1370 STEWART ST

PRIORITIES & BOARD RECOMMENDATIONS

After visiting the site, considering the analysis of the site and context provided by the proponents, and hearing public comment, the Design Review Board members provided the following siting and design guidance.

THE PODIUM + THE STREET

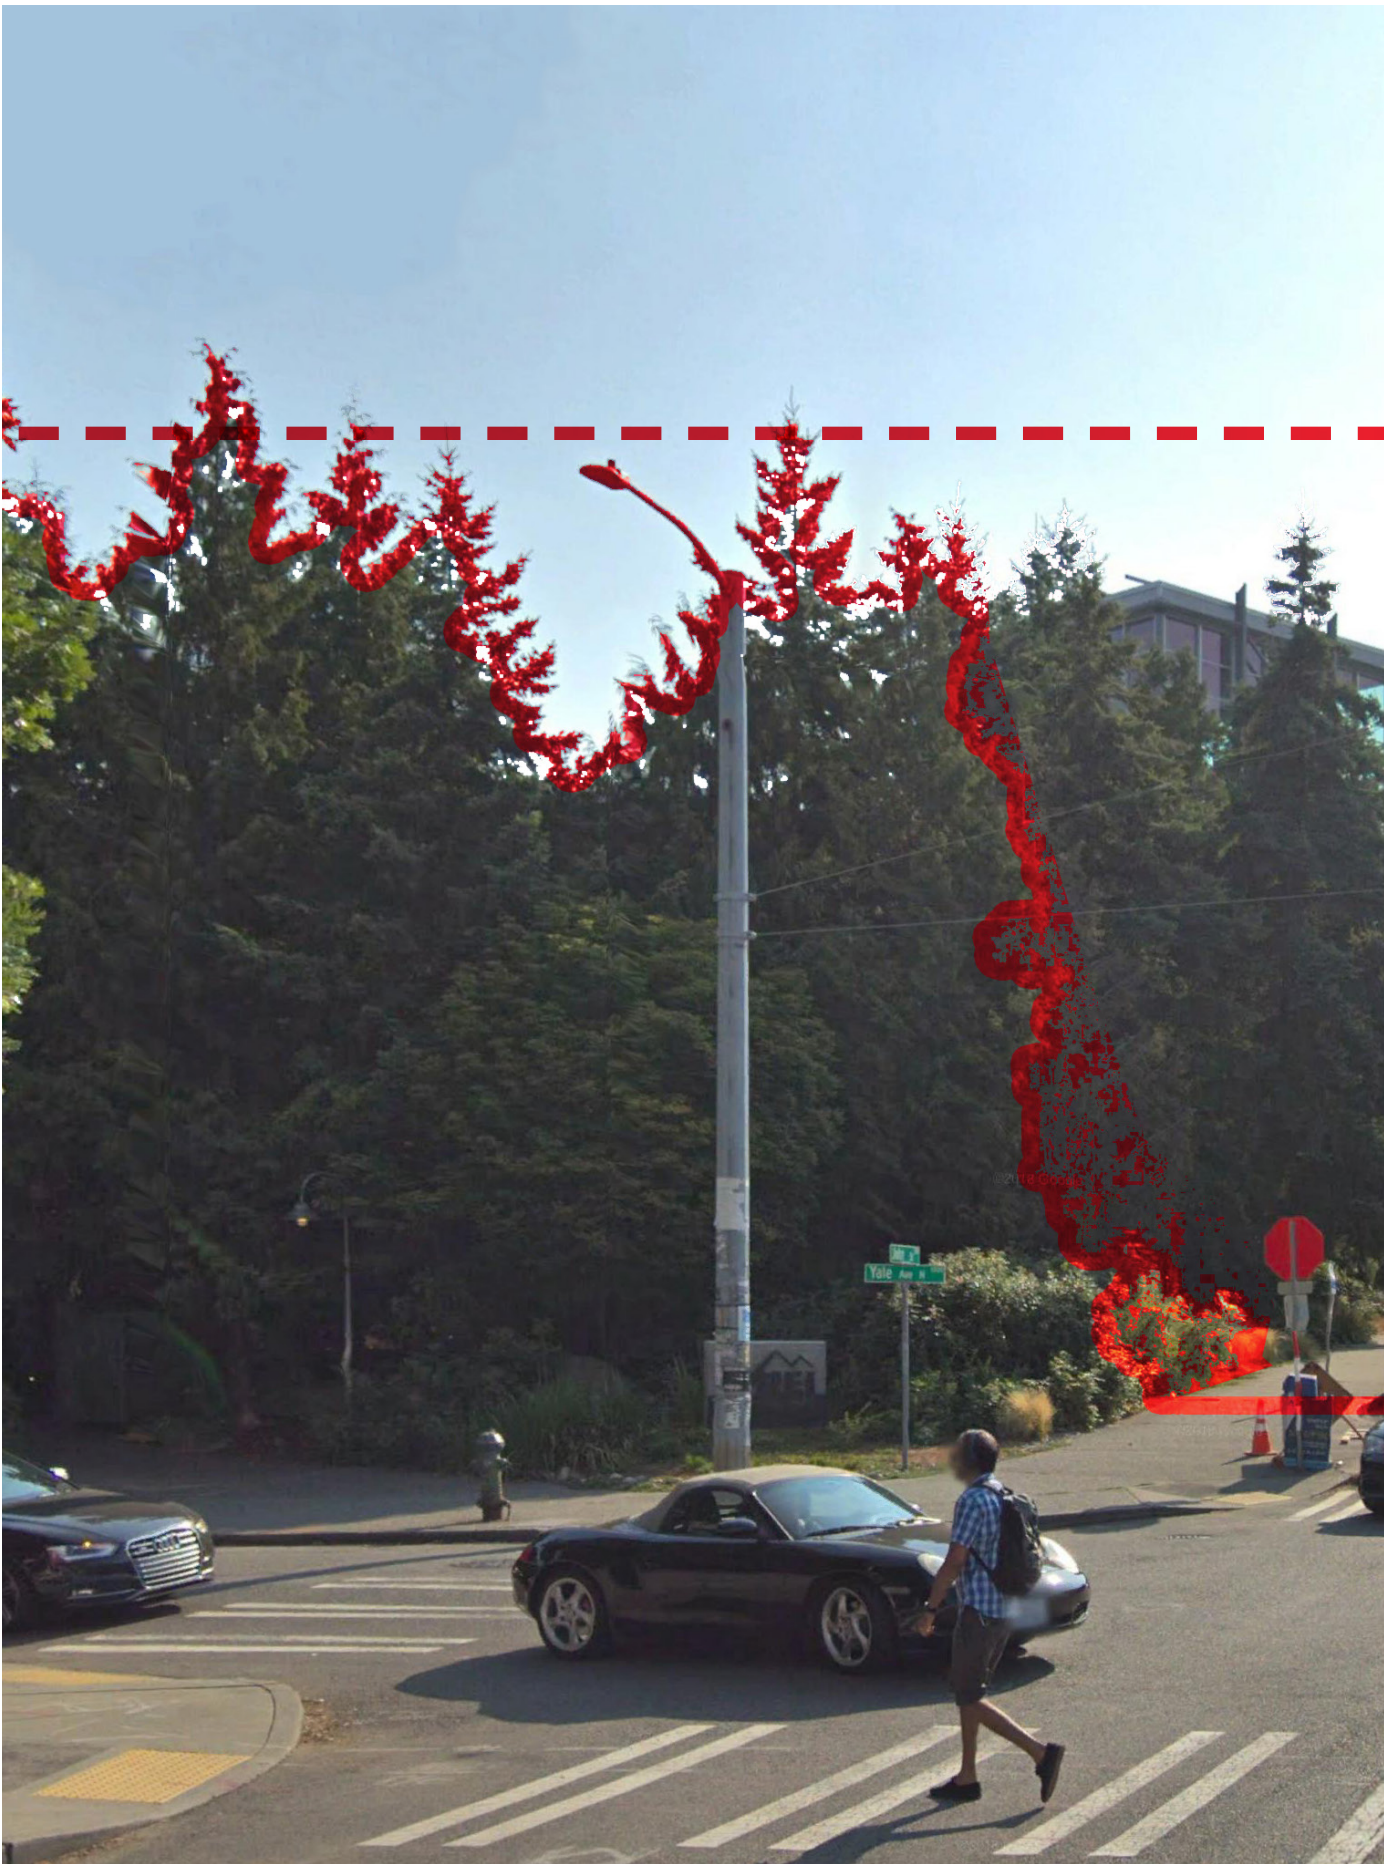
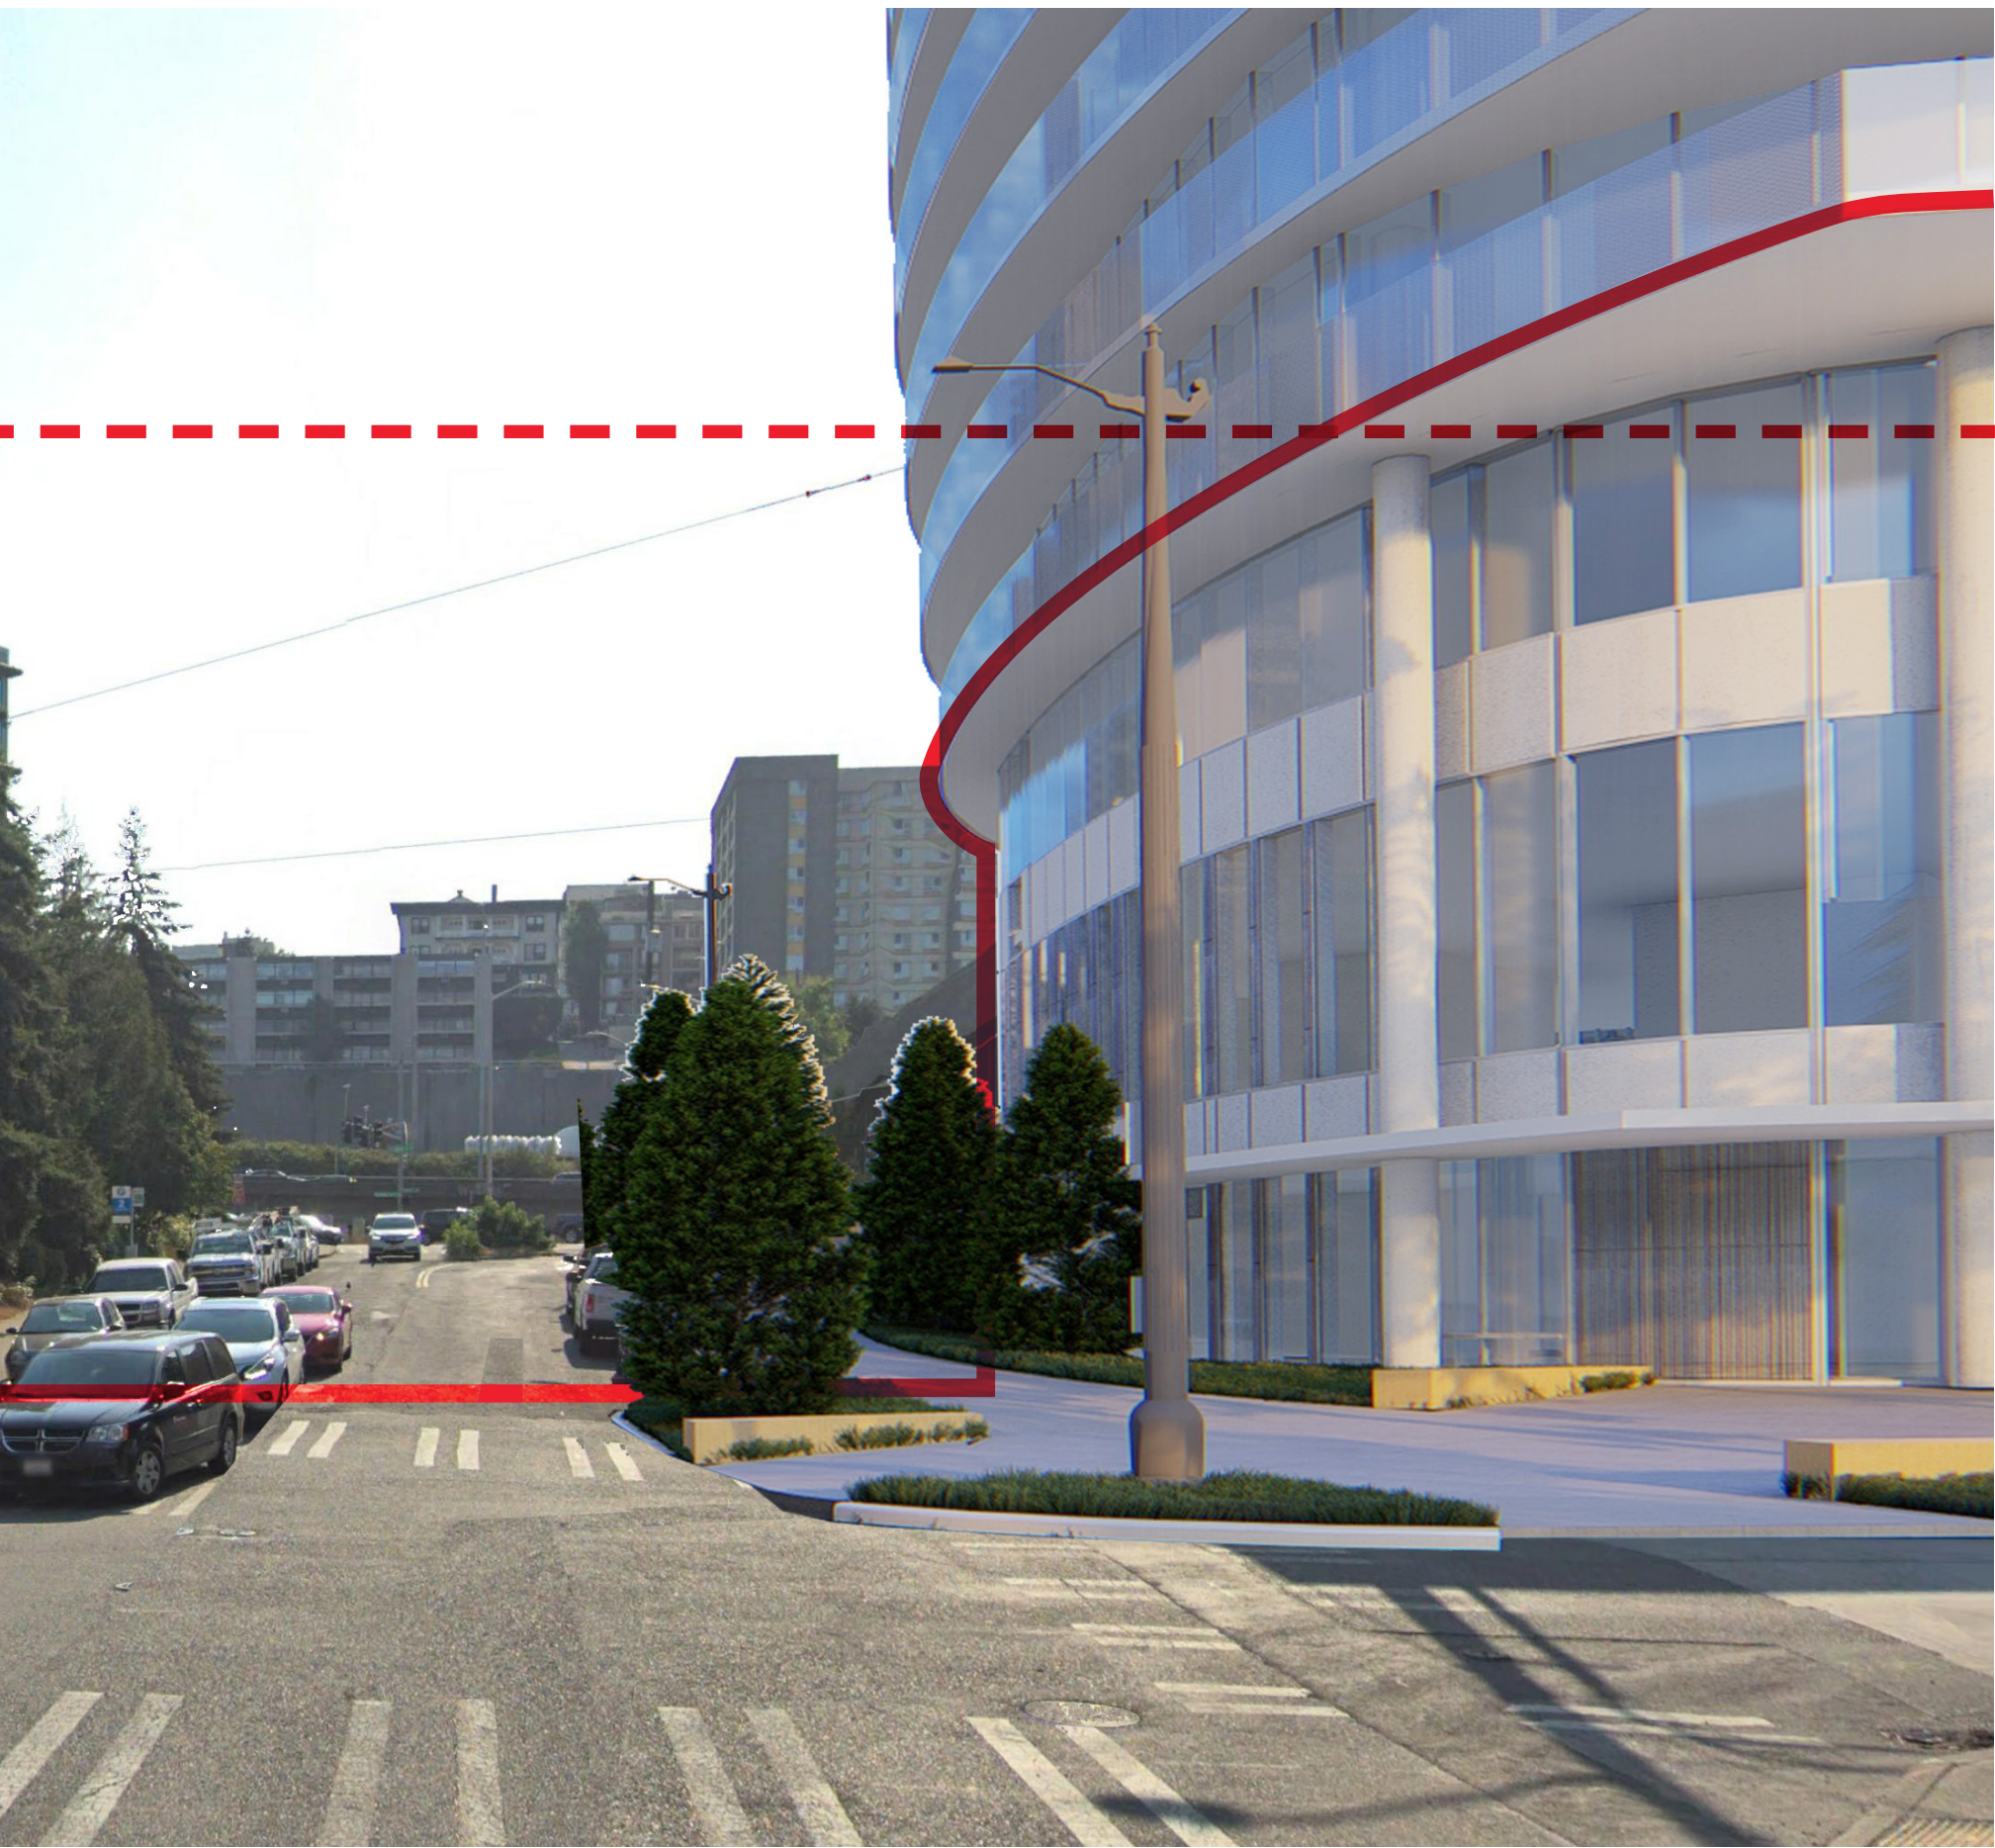
4B. The Board was frustrated by the limited number of design drawings and lack of analysis around pedestrian-level conditions on Yale and John Streets and agreed that they were struggling to see a design rationale for the podium. (DC2-3, DC2-1)

- i. As such, The Board found that they were unable to evaluate the design of the podium either as a response to context or in relation to the tower.

4C. The Board was frustrated by the limited number of design drawings and lack of analysis around pedestrian-level conditions on Yale and John Streets and agreed that they were struggling to see a design rationale for the podium. (DC2-3, DC2-1)

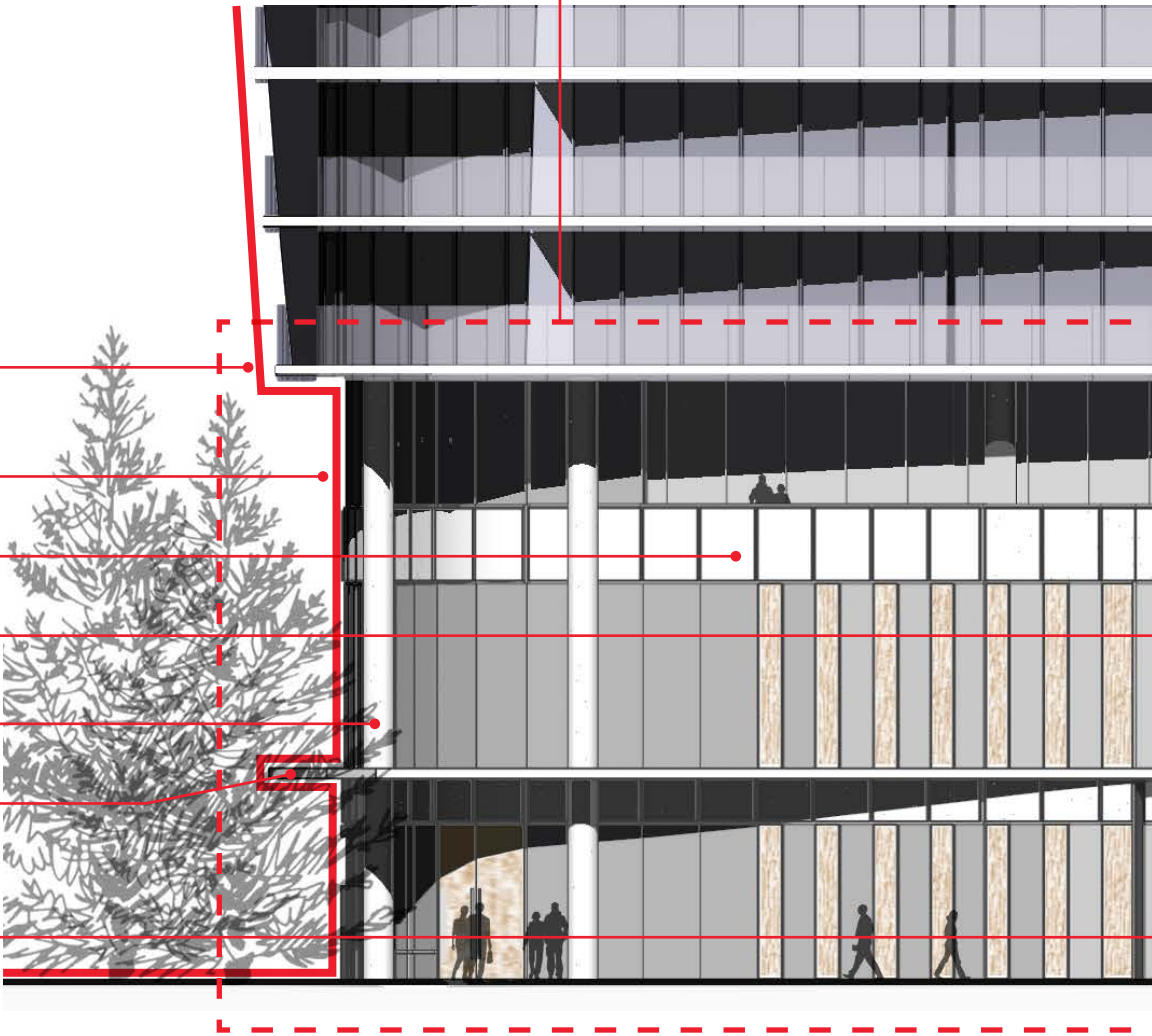
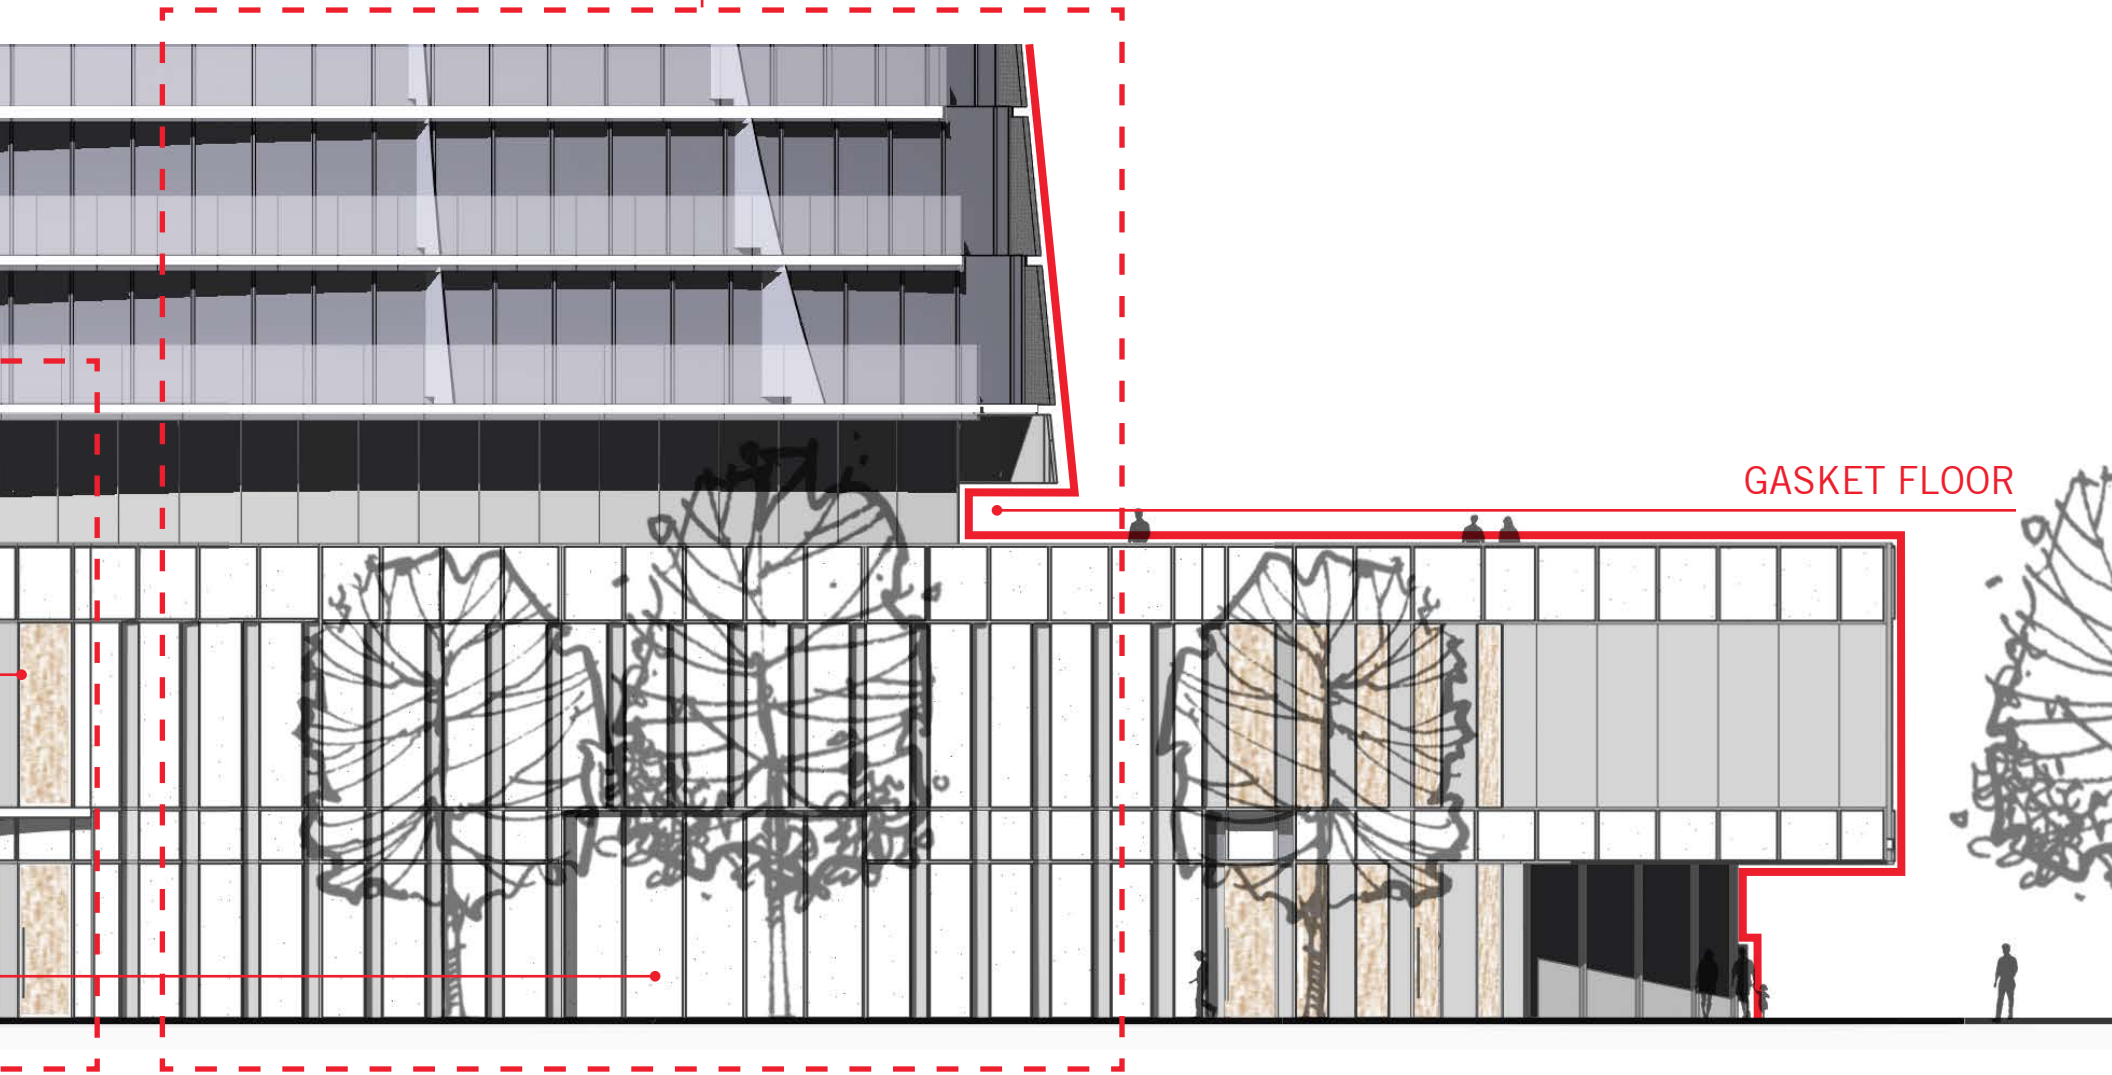
5B. The Board neither supported nor opposed the ‘glass box’ expression of the podium. The Board agreed that although there is no context precedent that would support this choice, the unique location at this unusual triangular site adjacent to I-5 would support a wide variety of solutions, including one not directly connected to context. (CS2-A, CS2-4, CS3-A-2)

5C. Regardless of the direction the podium design takes, the Board asked to see a clear design connection between the materiality of the base and the tower. The design should express a logical scheme for human scale elements in the pedestrian zones. (DC2-2, DC2-3)

SCALING ELEMENTS
Skin recess and material change
differentiate podium from tower.
